To: Elizabeth Boepple, Vice Chair, and Members of the Portland Planning Board
From: Nell Donaldson, Planner
Date: April 8, 2016
Re: Waynflete Gym and Lower School
Project #: 2016-034 **CBL:** 61-F-2, 3, 4, 5, 6, 7, and 11
Meeting Date: April 12, 2016

The Waynflete School has requested preliminary Level III site plan review for the construction of new gymnasium and Lower School facilities on their 5.6 acre campus in the city's West End. The project involves the demolition of the existing gym, replacement with a new 13,000 SF building, the renovation and expansion of the Lower School, and the construction of new outdoor play spaces. Sidewalk, stormwater and utility upgrades are also proposed.

Re: 360 Spring St. – Waynflete School Campus Upgrade

C-100

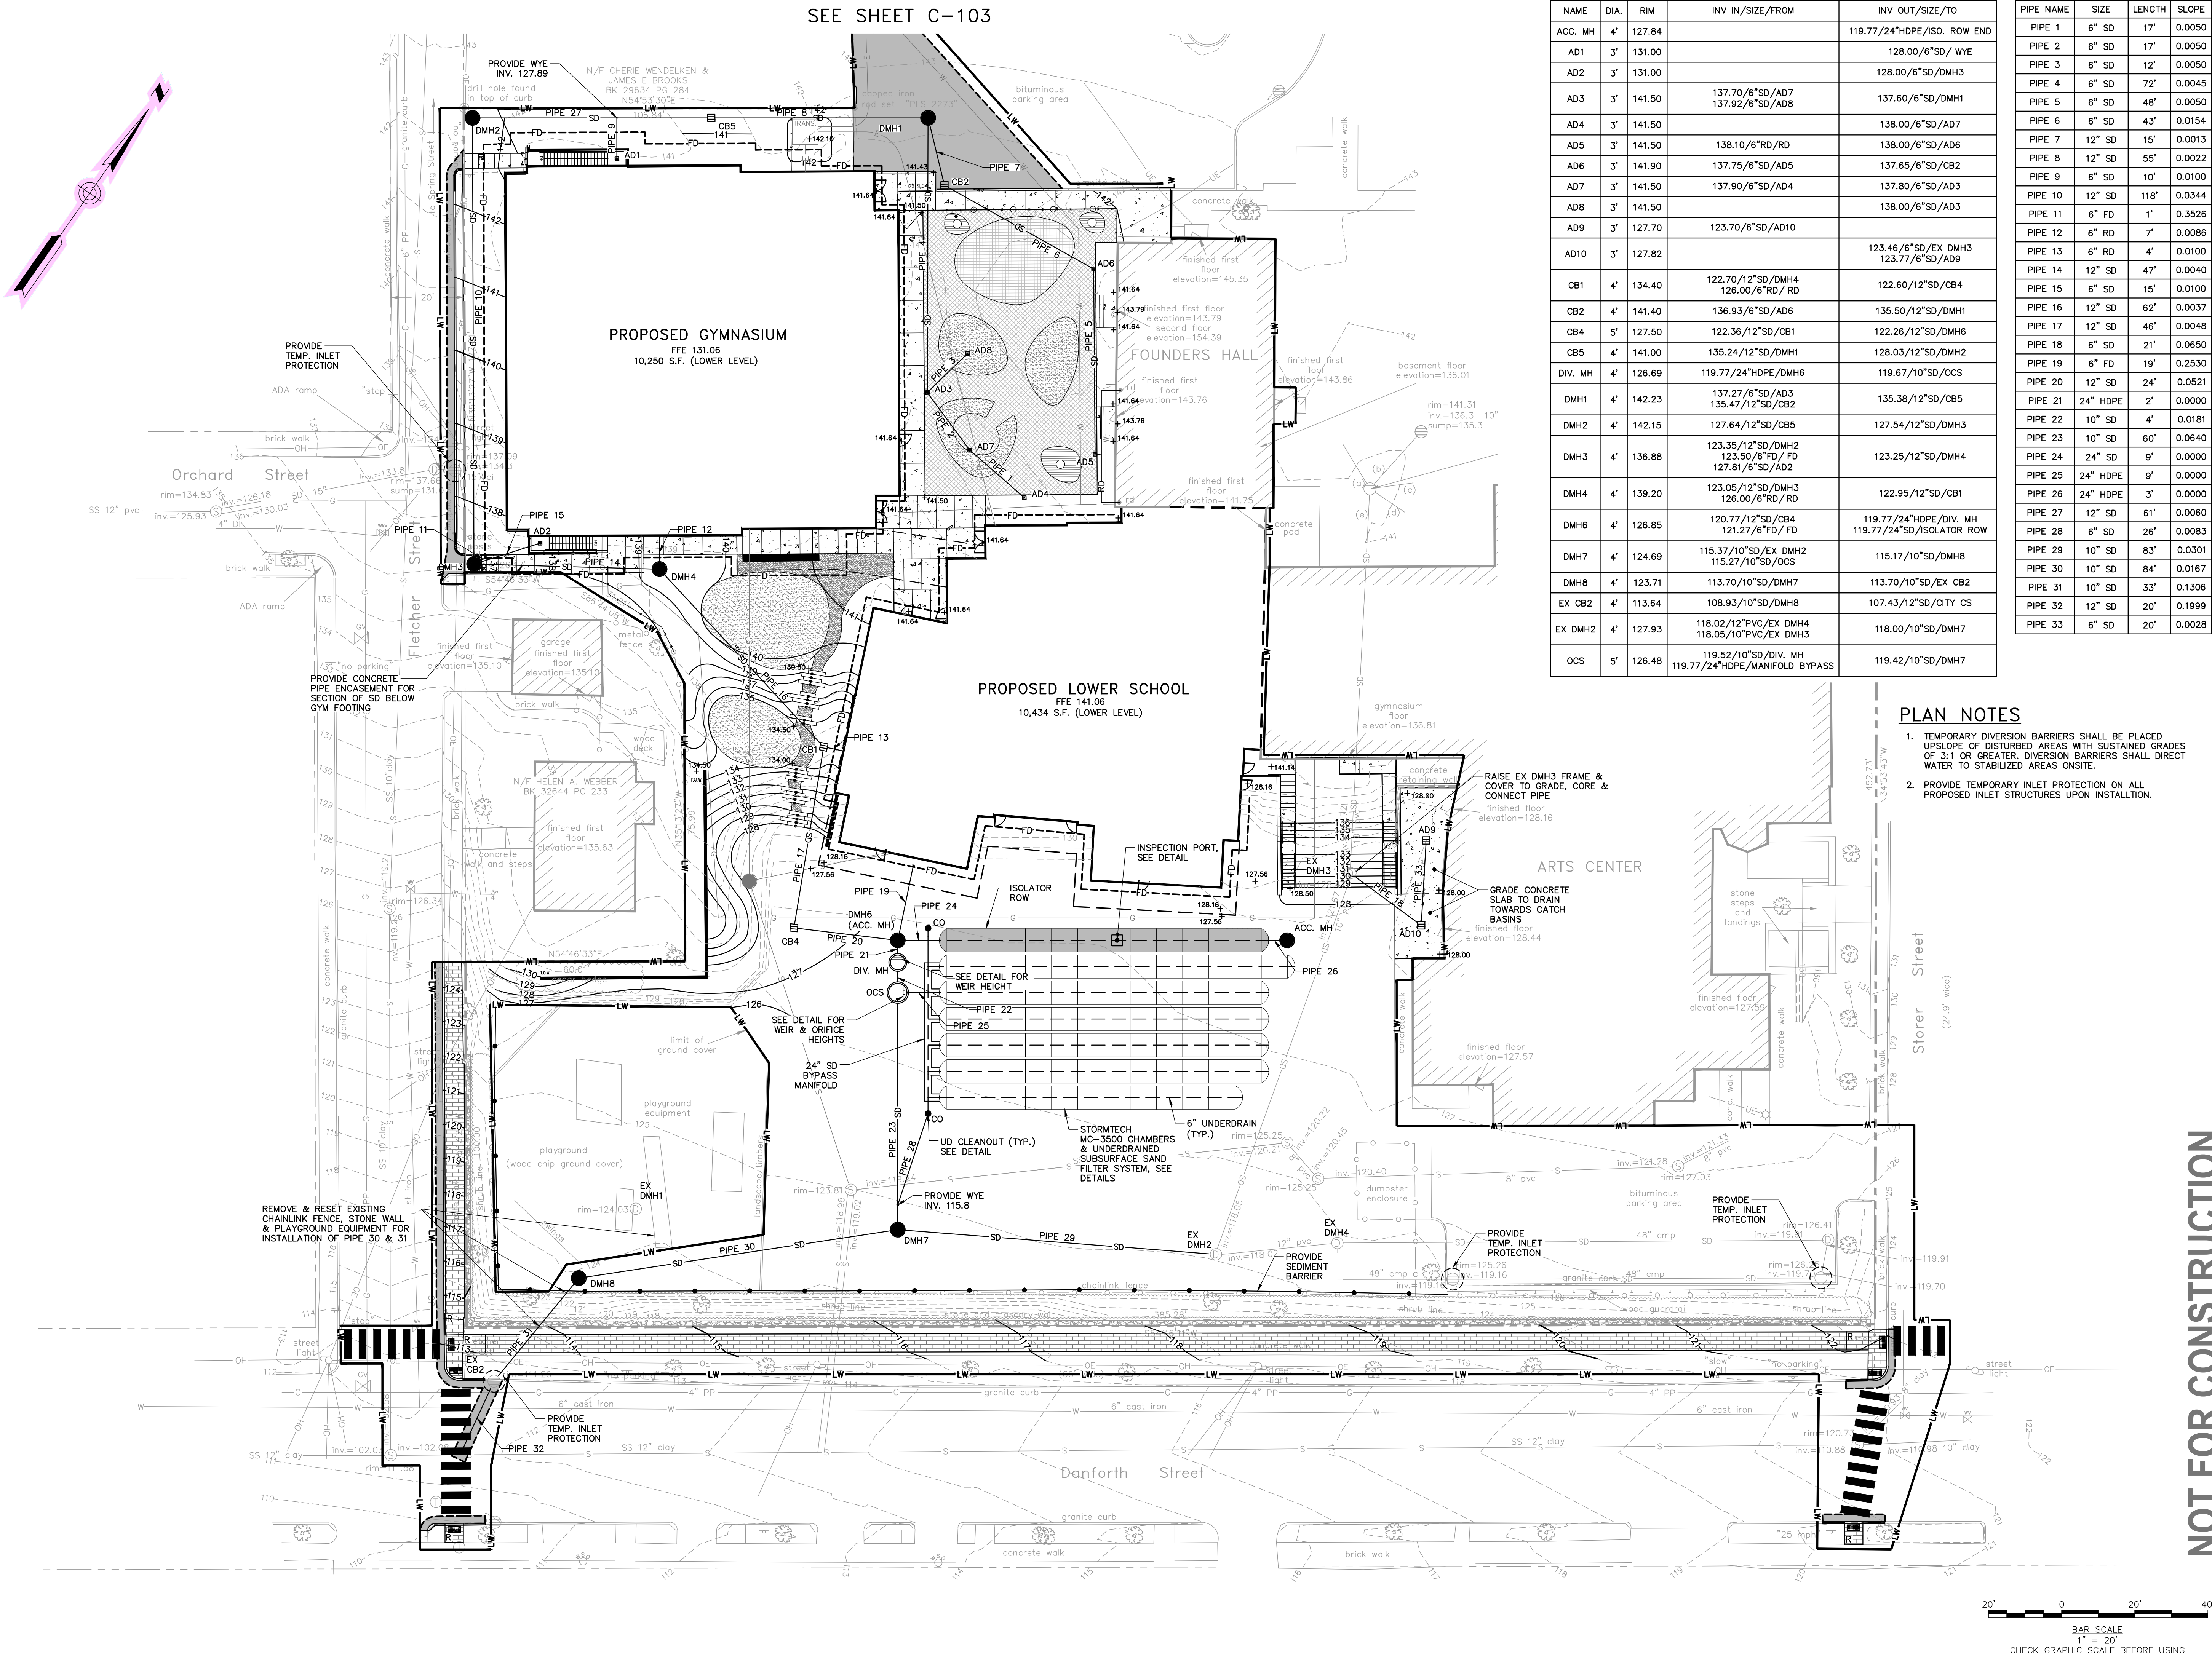
The ramps, as shown in D202 (the detail sheet) and the Site Plan in C100, are not ADA compliant. If the ramps are to be constructed as shown, the Detectable Warning Panels need to extend the full width of the ramp (the flush area), not with two individual panels. The ramp detail on Sheet D202 should also provide additional information on grades on

The ramps, as shown in D-202 (the detail sheet) and the Site Plan in C-100, are not ADA-compliant. If the ramps are to be constructed as shown the the Detectable Warning Panels need to extend the full width of the ramp (the flush area), not with two individual panels. The ramp detail on Sheet D-202 should also provide additional information on grades on the ramps (e.g., 8% on the ramping down, and maximum of 2% cross-slopes on the landing areas within the ramp. They should indicate how the grades within the landing area of the ramp will prevent ponding of water within the landing area and also at the base of the ramp where it meets the street (a typical problem that needs to be avoided).

In their most recent submittal, the applicant notes that additional coordination around the location of crosswalks, ramps, and renovated sidewalks will be required. These questions will be resolved prior to final site plan review.

D-202

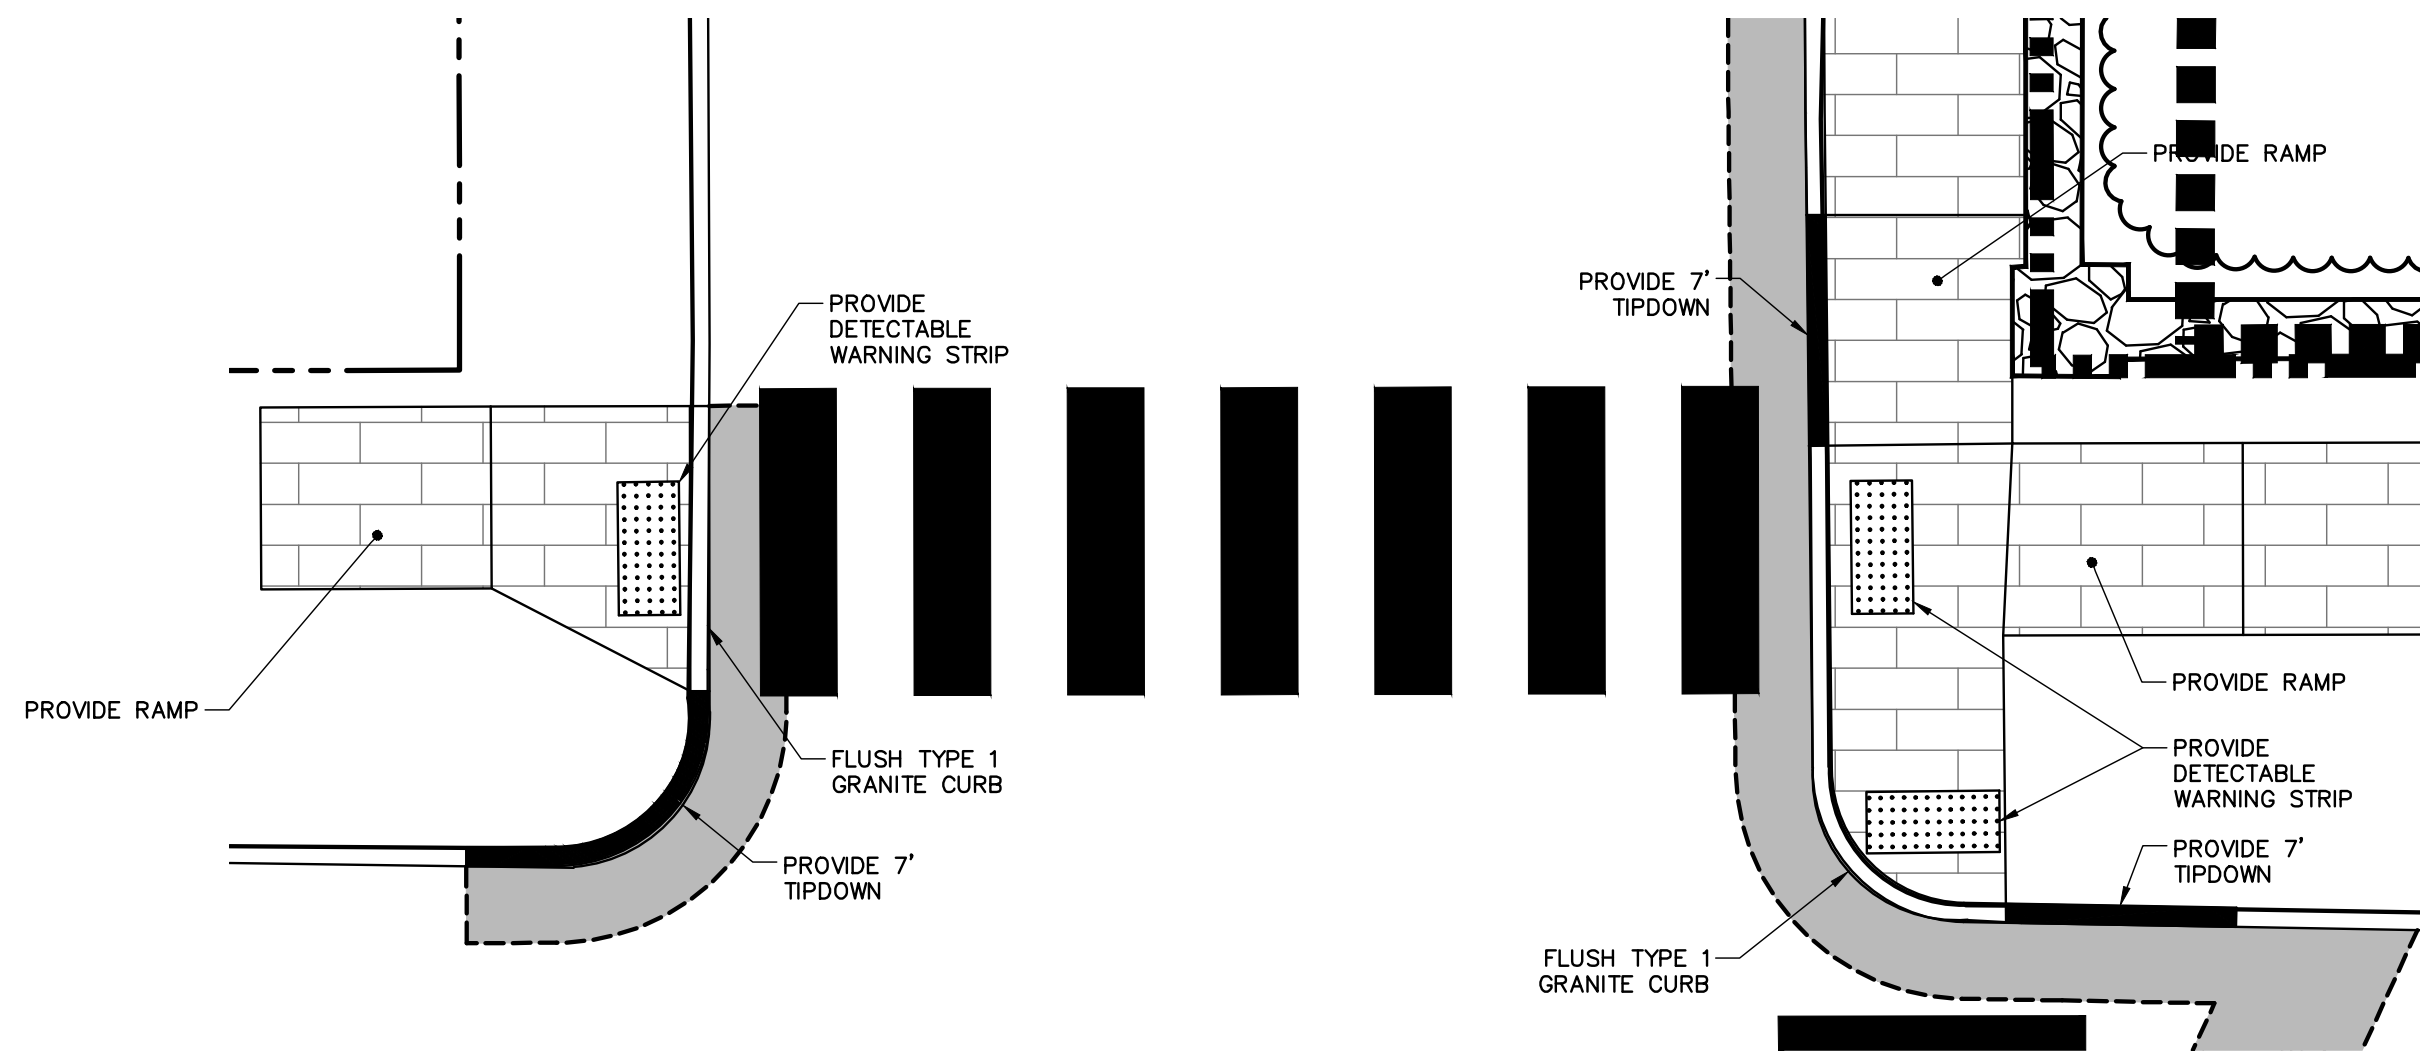
For the ramping down portions of the ramps, there may need to be curb at the backside of the ramp for proper ramping down. The detail needs to be clearer for the contractor.
